MARK	REVISIONS	BY	APPR.	DATE
▲	REVISED WILDLIFE FENCE MESH	NCM	ADDEN#3	04/16/2024

**CONSTRUCTION DETAILS**  
**HSIP-GILMAN SPRINGS RD**  
FROM 8,920' S/O ALESSANDRO  
BLVD TO 5,340' S/O BRIDGE ST

ISSUED BY ADDENDUM No. 3, ATTACHMENT "A"

**WILDLIFE GATE INSTALLATION**  
NTS

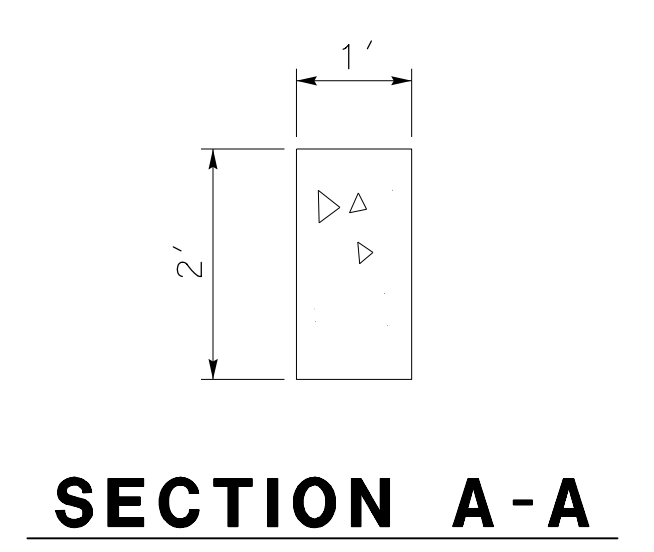
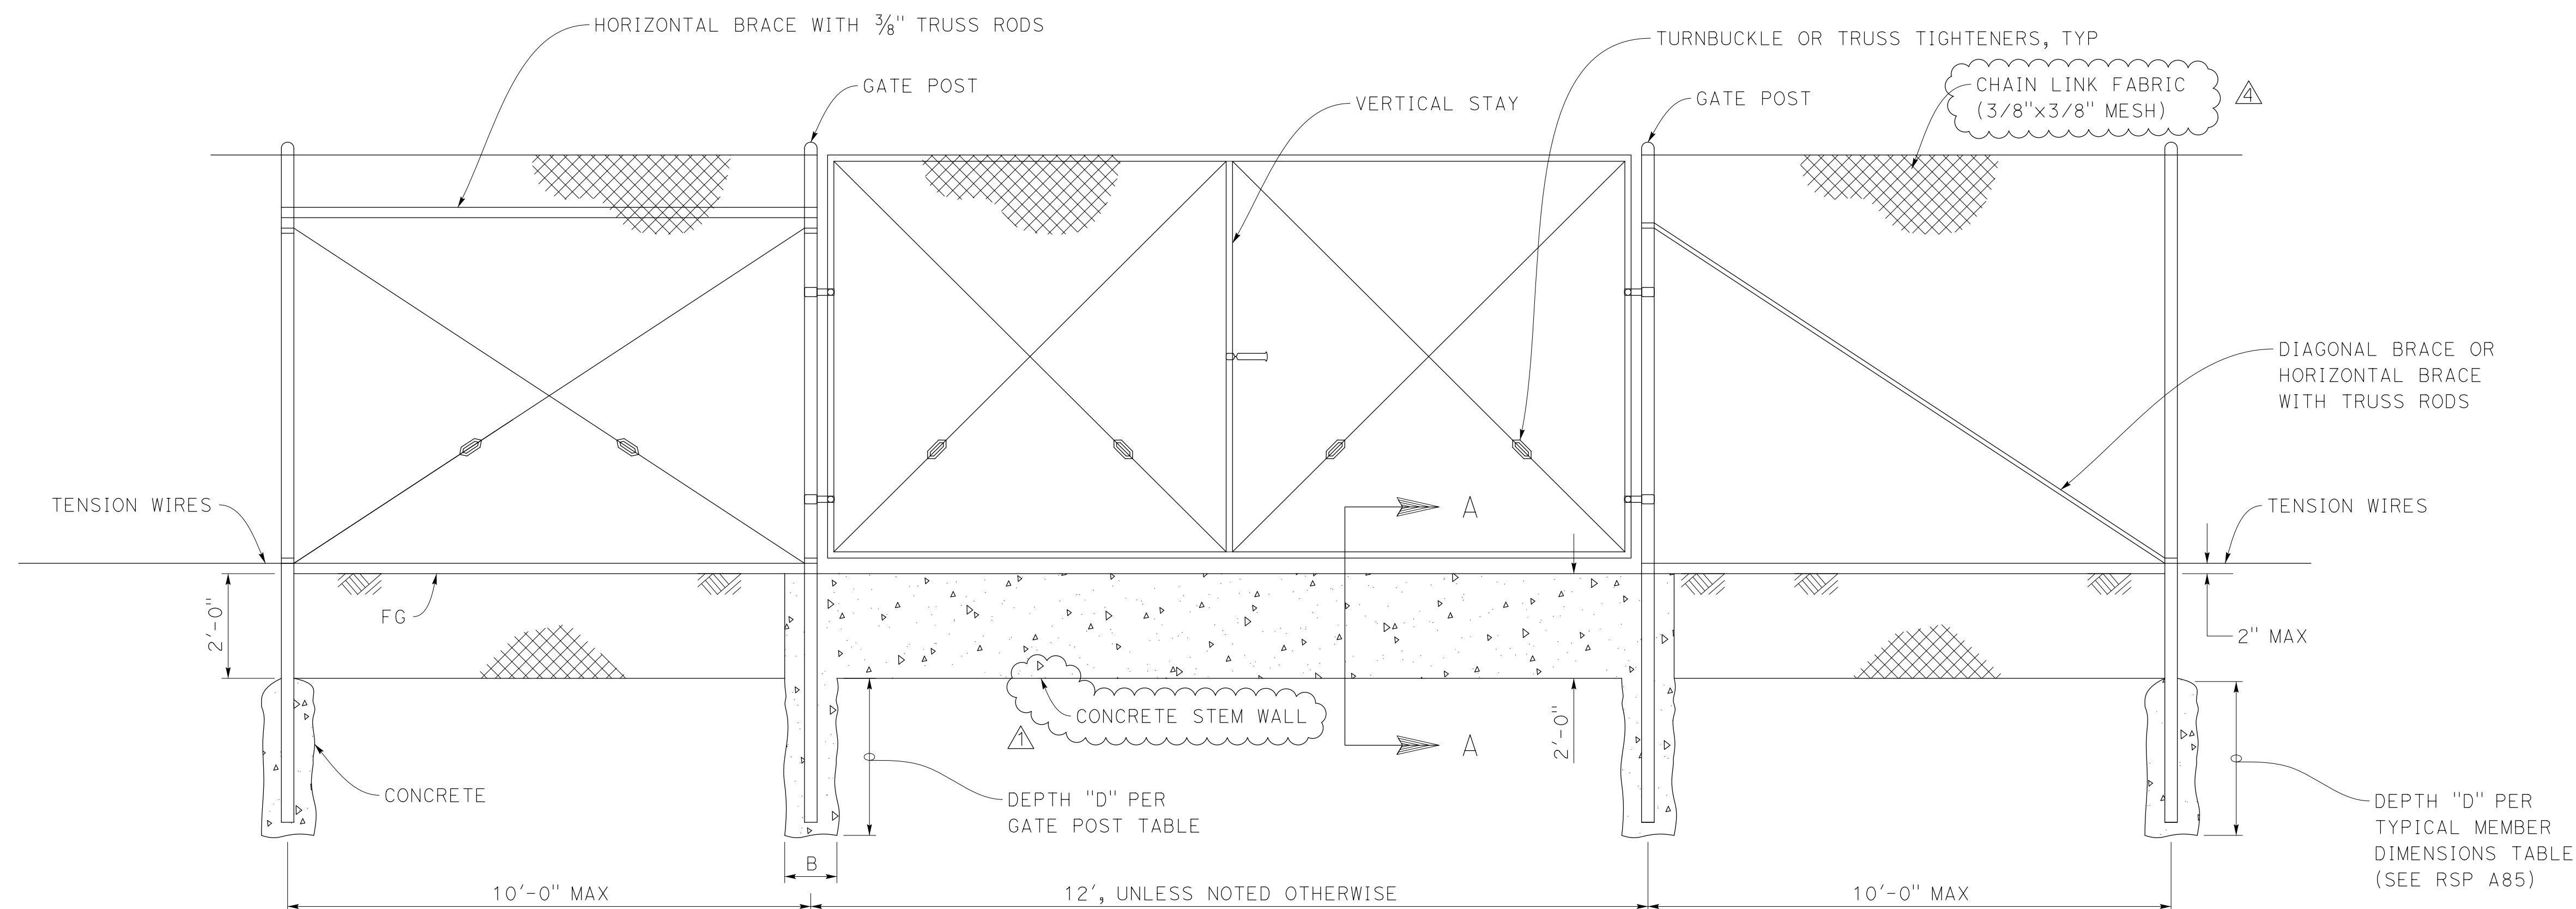
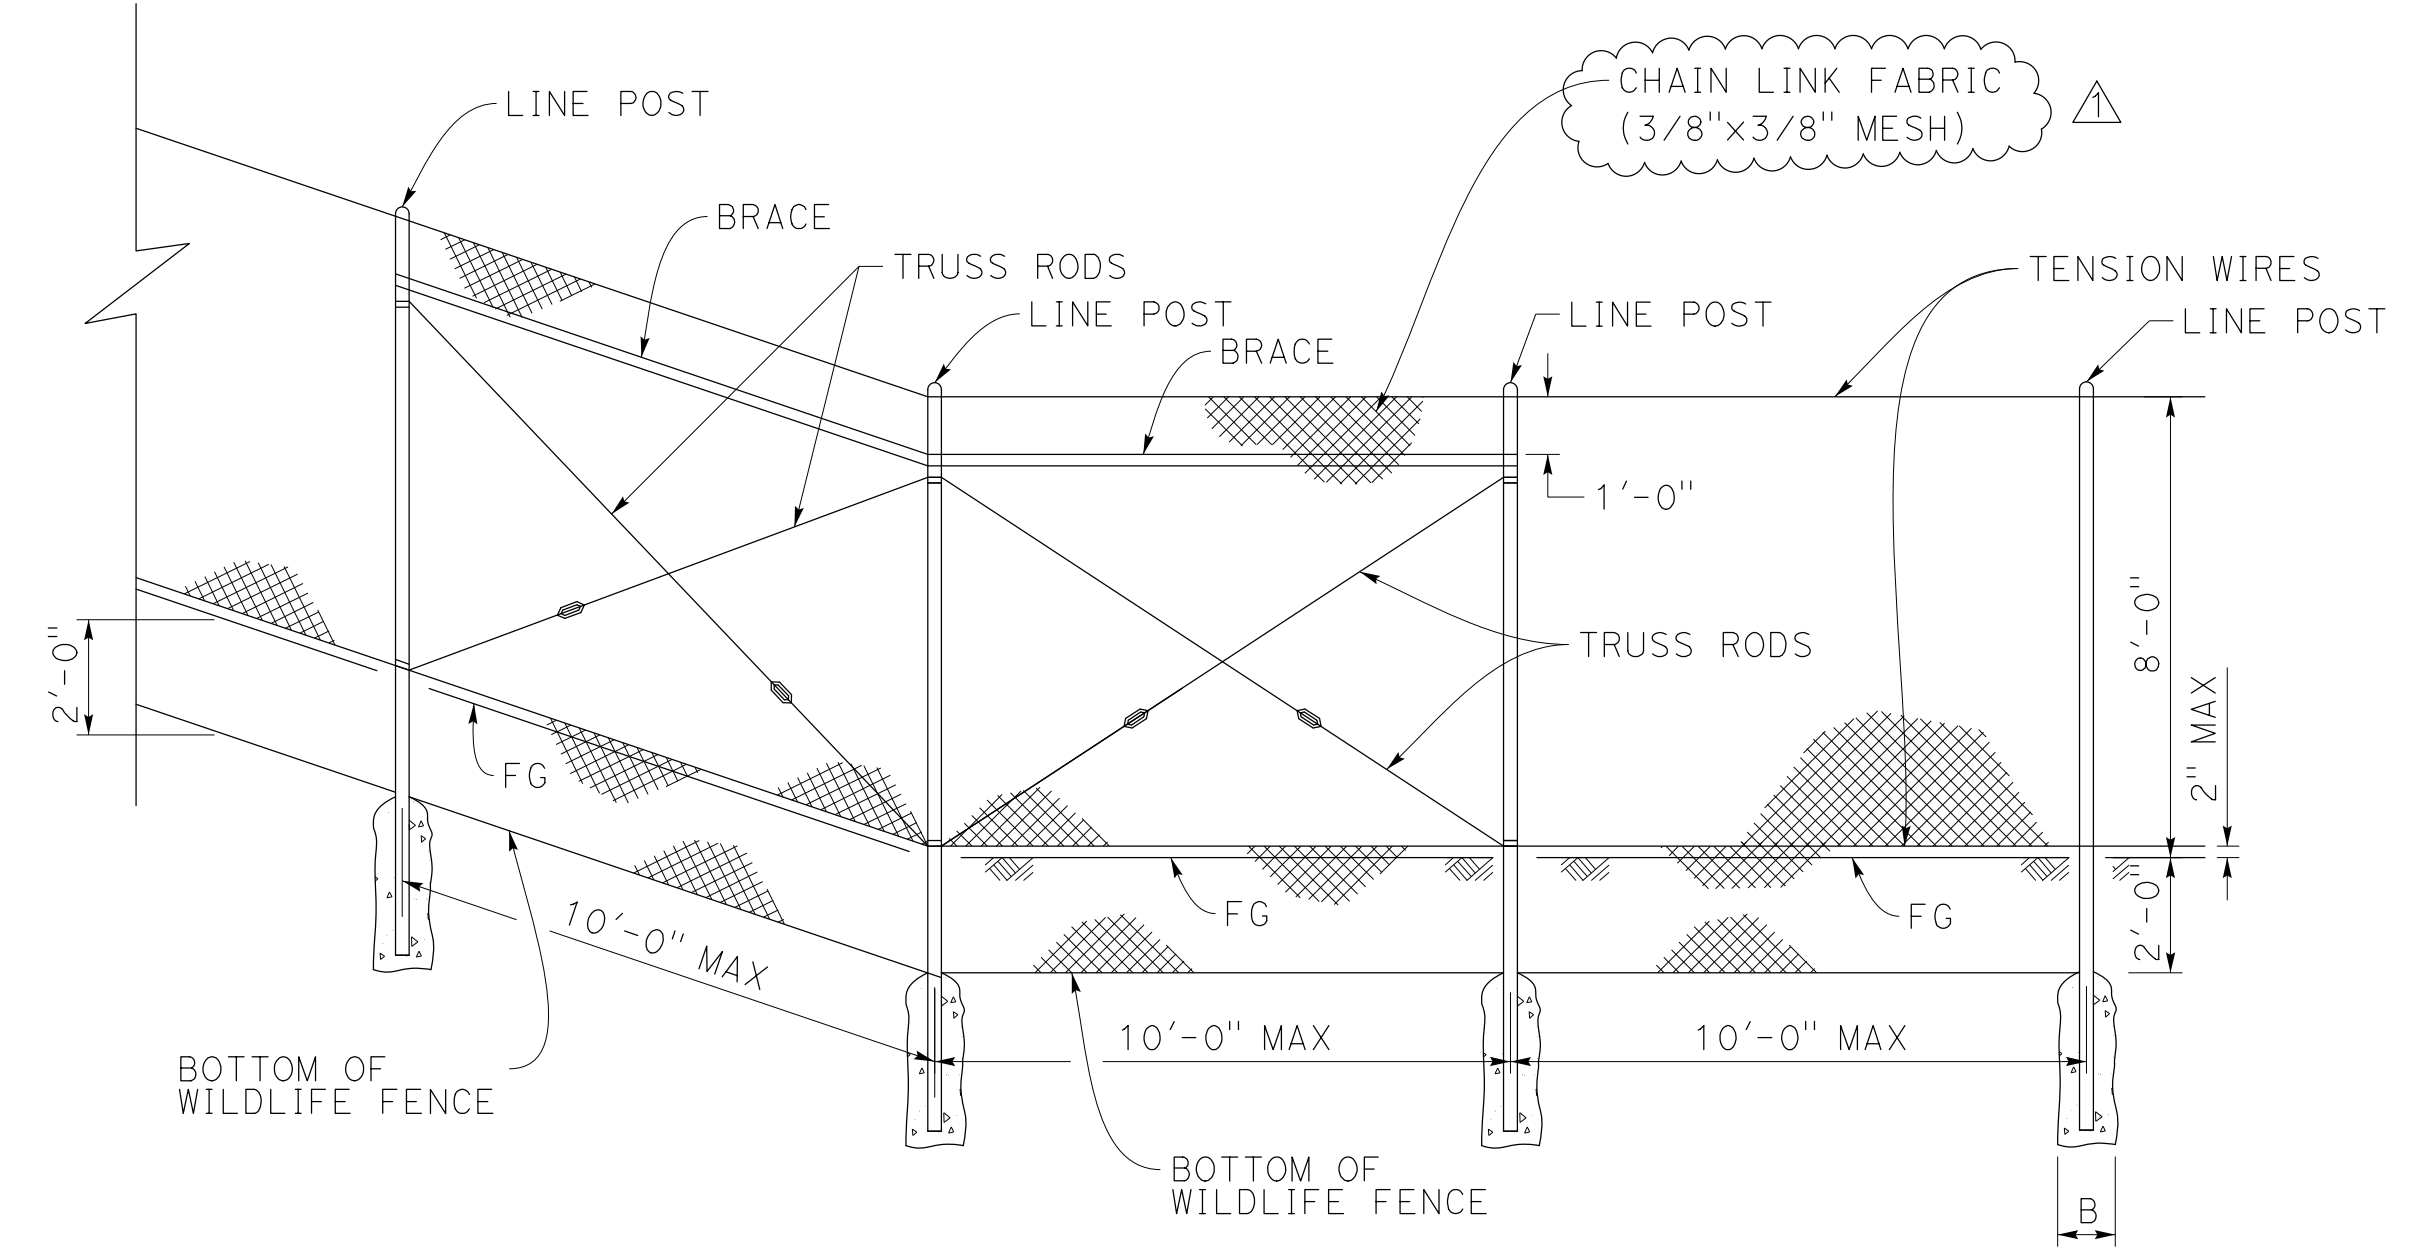
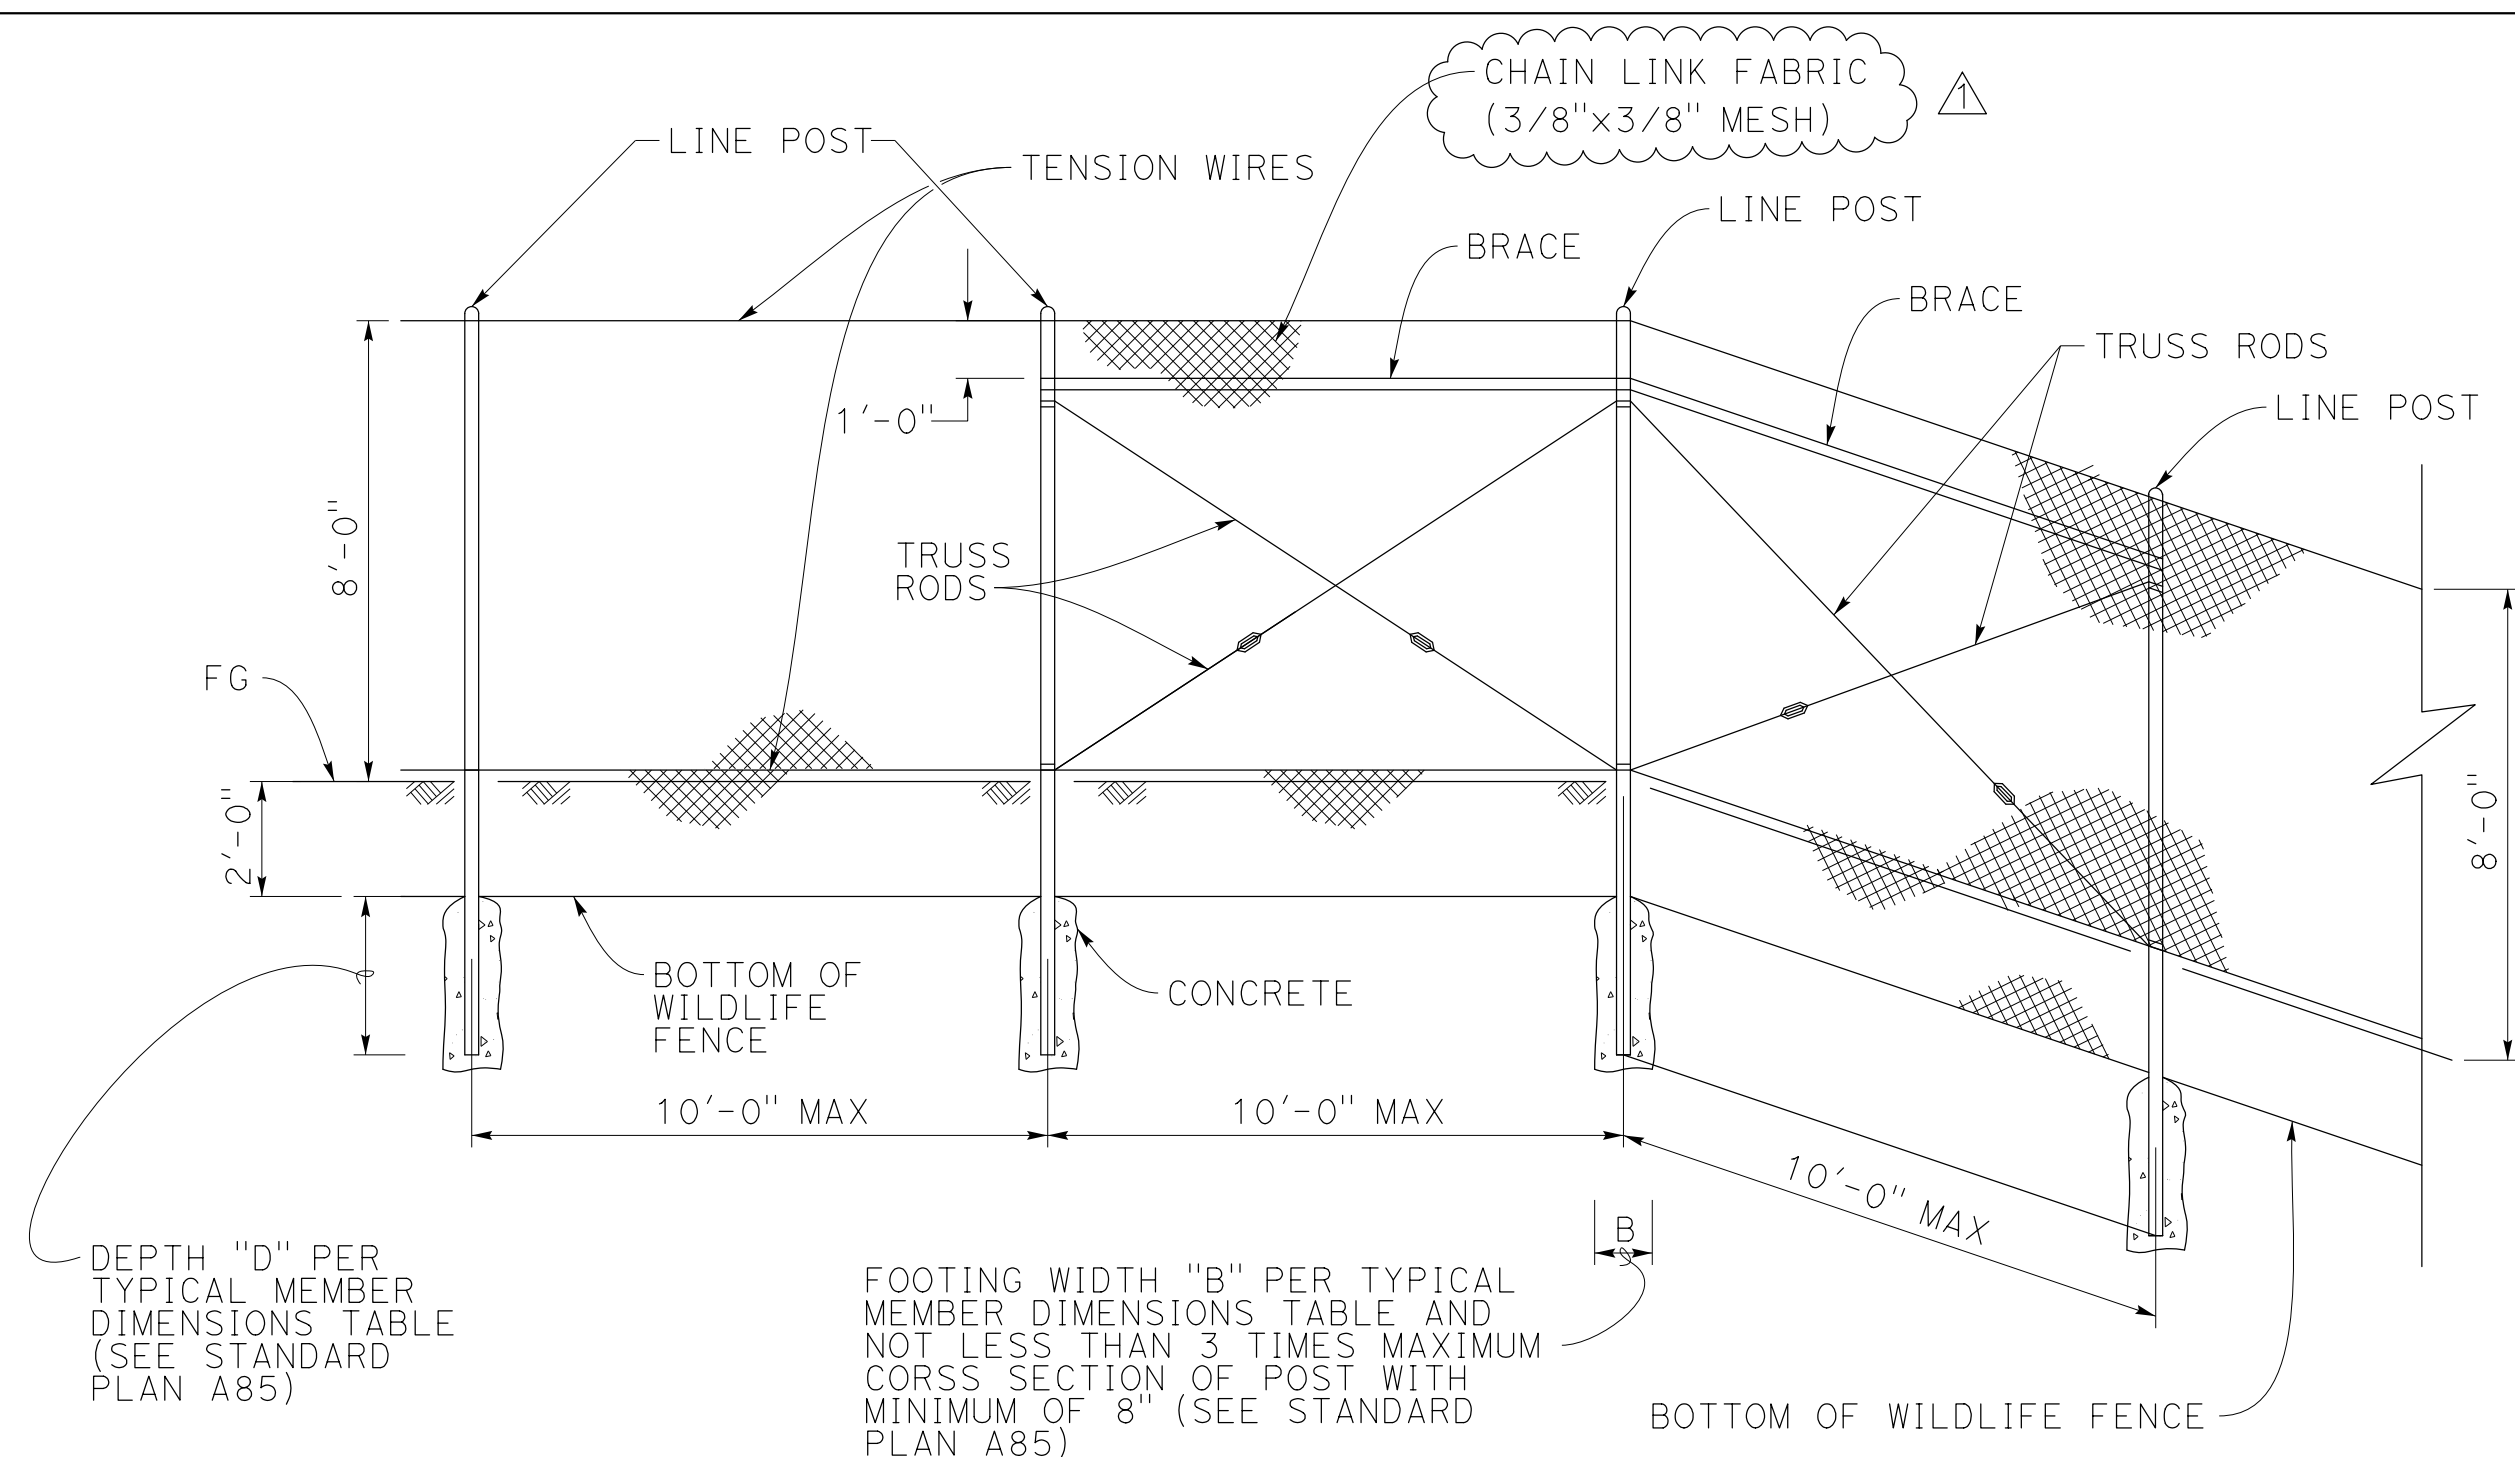
MARK	REVISIONS	BY	APPR.	DATE
△	REVISED WILDLIFE FENCE MESH	NCM	ADDEN#3	04/16/2024
△	CLARIFIED DIRECTION OF WIRE TOPPER	NCM	ADDEN#1	04/09/2024
△	CHANGED BARBED WIRE TO SMOOTH WIRE	NCM	ADDEN#1	04/09/2024
△	NOTED MATERIAL FOR GATE WALL	NCM	ADDEN#1	04/09/2024
